# UNITED STATES PATENT AND TRADEMARK OFFICE

10/599,491

<b>Office Action Summary</b>	<b>Application No.</b> 10/599,491	<b>Applicant(s)</b> INNOCENTI ET AL.	
	<b>Examiner</b> Daniel J. Colilla	<b>Art Unit</b> 2854

## **DETAILED ACTION**

Fig. 3

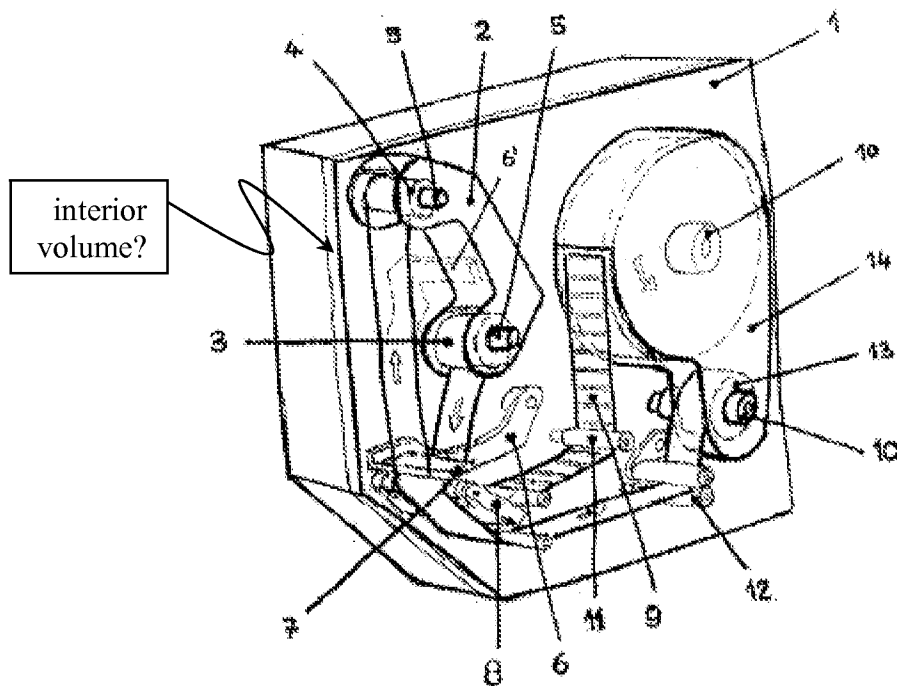
2. With respect to the objection to the drawings applicant state that the structure indicated by reference numeral "1" is an "enclosing structure" as recited in claim 1. However, as shown below in the Figure taken from applicant's drawings, reference numeral 1 appears to indicate a base upon which the printing structure is mounted:

If applicant is referring to the line which appears to go around the top of the mounting structure as the enclosing structure, this is not clearly shown in the drawings. Furthermore, this structure does not appear to enclose the printing structure as recited in the claim.

3. The drawings are objected to under 37 CFR 1.83(a). The drawings must show every feature of the invention specified in the claims. Therefore, the “**enclosing structure**” as recited in claim 5 must be shown or the feature(s) canceled from the claim(s). No new matter should be entered.

Corrected drawing sheets in compliance with 37 CFR 1.121(d) are required in reply to the Office action to avoid abandonment of the application. Any amended replacement drawing sheet should include all of the figures appearing on the immediate prior version of the sheet, even if only one figure is being amended. The figure or figure number of an amended drawing should not be labeled as “amended.” If a drawing figure is to be canceled, the appropriate figure must be removed from the replacement sheet, and where necessary, the remaining figures must be renumbered and appropriate changes made to the brief description of the several views of the drawings for consistency. Additional replacement sheets may be necessary to show the renumbering of the remaining figures. Each drawing sheet submitted after the filing date of an application must be labeled in the top margin as either “Replacement Sheet” or “New Sheet” pursuant to 37 CFR 1.121(d). If the changes are not accepted by the examiner, the applicant will be notified and informed of any required corrective action in the next Office action. The objection to the drawings will not be held in abeyance.

**FIG.12**

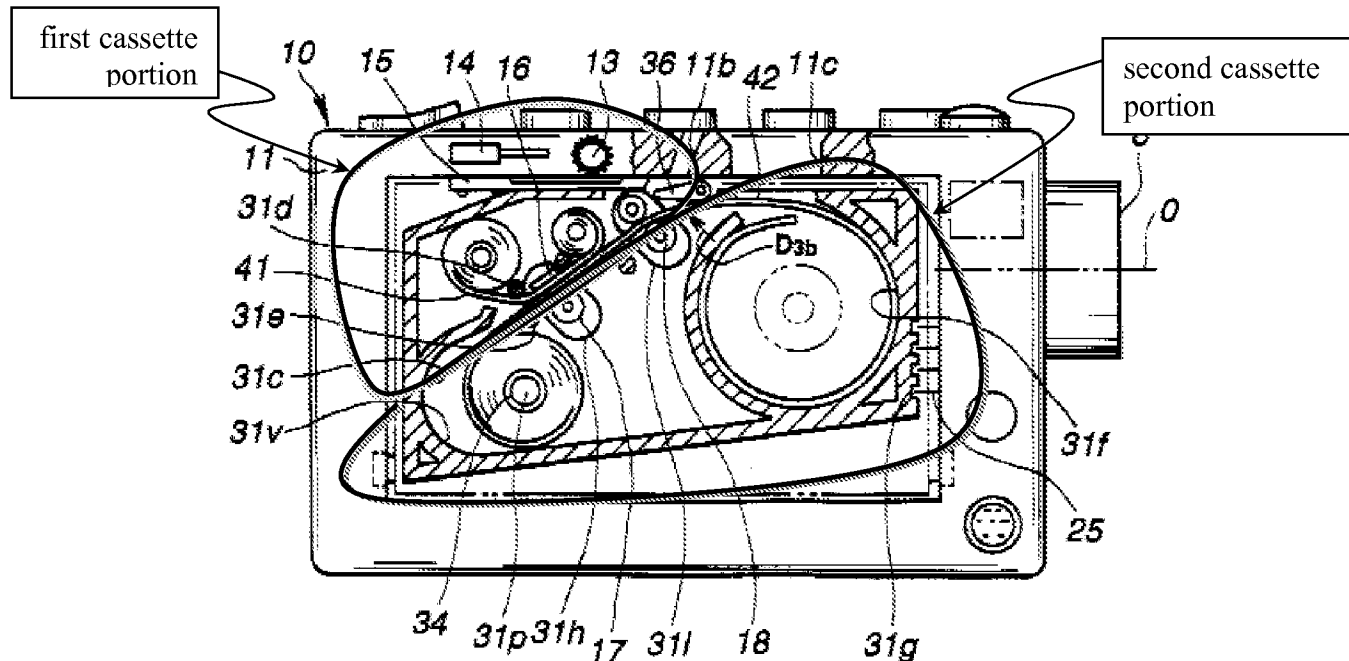
Nagasaki *et al.* discloses a thermal transfer printer apparatus comprising: an enclosing structure 11 having an interior volume; a thermal printhead 16 positioned in said enclosing structure 11; a first cassette portion positioned in said interior volume of said enclosing structure as shown below in the figure taken from Fig. 12 of Nagasaki *et al.*:
